GROUP BODY	MODEL Sorento (XMa) 2014MY
NUMBER 094	DATE March 2013

TECHNICAL SERVICE BULLETIN

SUBJECT: LIFTER BRACKET REPLACEMENT FOR SORENTO POWER TAILGATE SYSTEM

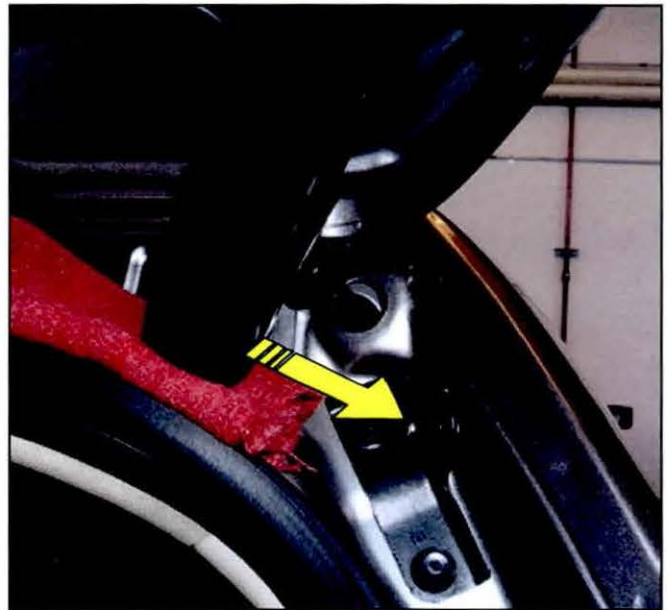
5. Remove the two retaining bolts securing the right side tailgate lifter retaining bracket.

6. Replace the old bracket with the modified lifter mounting bracket. Make sure to apply upward pressure when tightening the retaining bolts to ensure bracket is as far up as possible.

Apply Loctite 242™ (Blue) to the bracket bolts.

Tightening Torque:
15.9~19.5 lb-ft (2.2~2.7 kgf-m)
